Yarra Planning Scheme Draft Amendment C271yara

Fitzroy and Collingwood Built Form Provisions

Submissions

Figure 1 – Victoria Parade indicative cross section

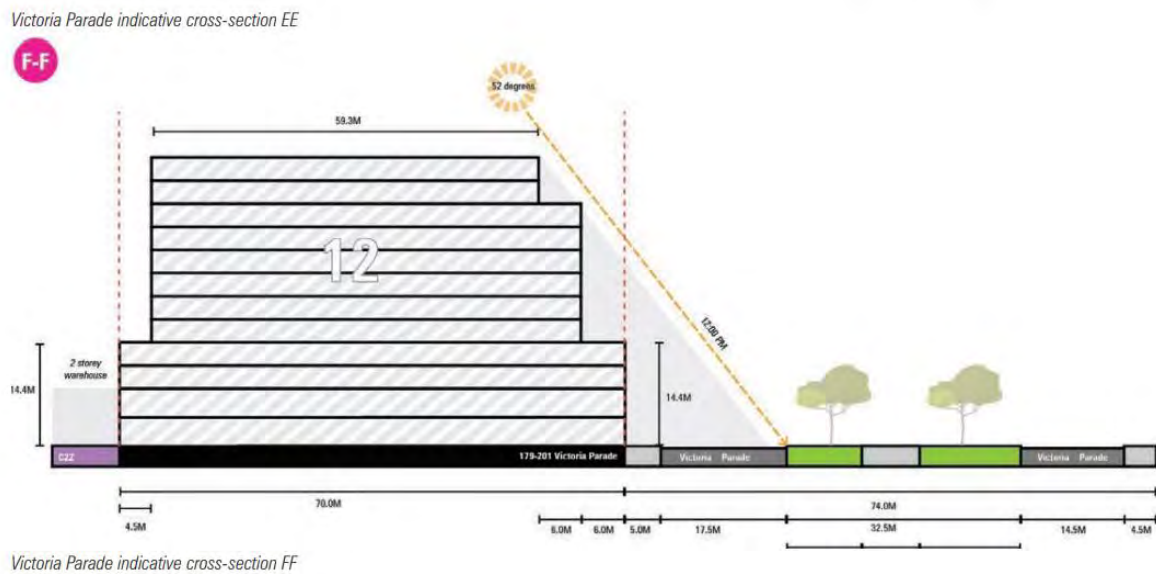
The cross section 'F-F' prepared demonstrates that this principle can be met by applying a 12 storey building height at the subject land. See Figure 1 below.

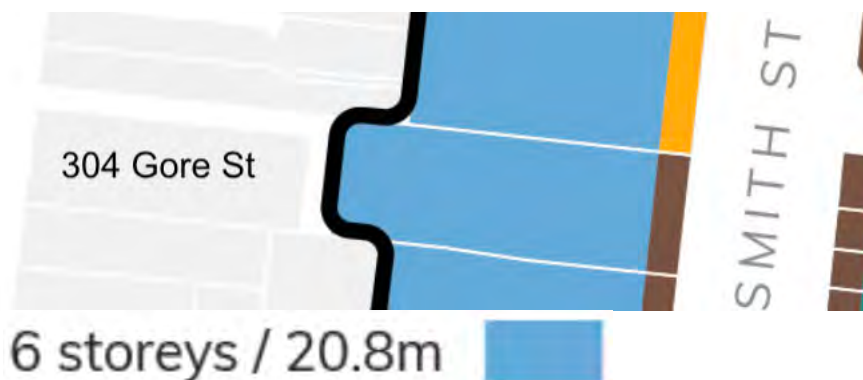
Via AMC271, It is proposed to rezone the portion of the land at 299 Smith St from Residential to Commercial with AMC271 citing the zoning as being an "anomaly".

While in most cases, we agree that zoning boundaries should follow property boundaries, given the history of 299 Smith Street and the extensive VCAT process, the zoning should remain as is in order to ensure that the time, resources and costs associated with the VCAT appeal and the outcomes that were agreed to be upheld. If the zoning changes as proposed via AMC271, then there is the real possibility that an amended application can be lodged for Planning Permit PLN20/0743 which can undo all the hard work associated with the VCAT process and importantly, the agreements that were reached.

Image 13: Part of Figure 4 Smith Street Foundation Information. Source: Smith Street Built form framework, Page 15

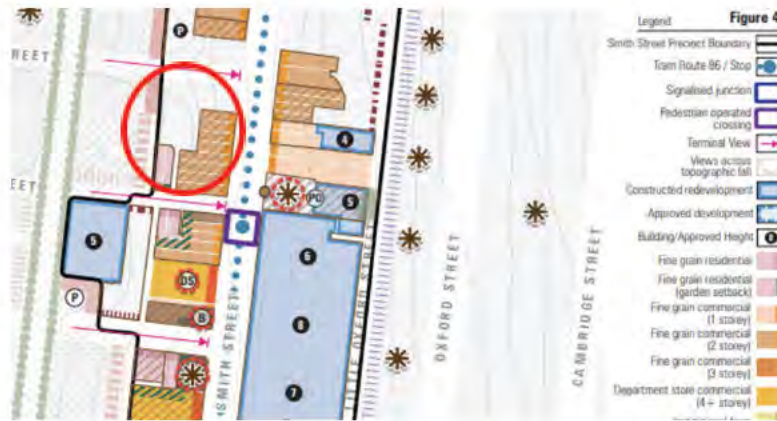
- i) Figure 4 (Smith Street Foundation information) Page 15 of the Smith Street Built Form Framework fails to identify 1-3 Charles Place Fitzroy as residential property. The purpose of the foundation information is to establish a catalogue of existing conditions. This study simply doesn't provide any assessment of 1-3 Charles Place Fitzroy. It does correctly identify 105 & 107 Charles Street as fine grain residential despite being within a commercial 1 zone which implies that not identifying 1-3 Charles Place as fine grain residential is an error in the study.

Image 14: Part of Figure 5 Smith Street emerging framework. Source: Smith Street Built form framework, Page 18

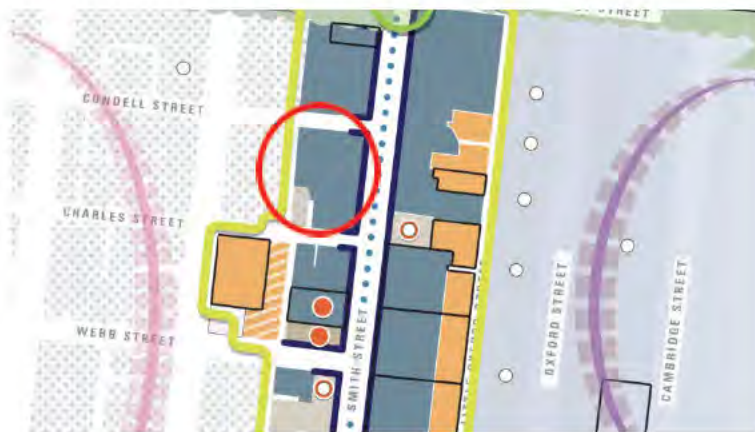
- ii) Figure 5 (Smith Street emerging Framework) Page 18 of the Smith Street Built Form Framework identifies 1-3 Charles Place Fitzroy as a 'moderate infill' site. Notably the same classification as 193, 195, 197, 199, 201, 203, 205, 207 & 209 Smith Street.

Image 15: Part of Figure 6 Smith Street built form control. Source: Smith Street Built form framework, Page 27

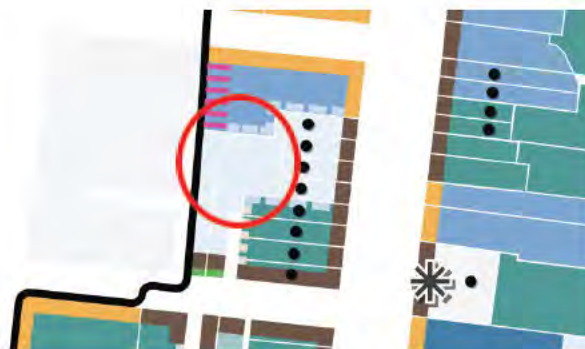
- iii) Figure 6 (Smith Street Built Form Control) Page 27 of the Smith Street Built Form Framework fails to identify the residential interface that exists between 1-3 Charles Place & 209 Smith Street.
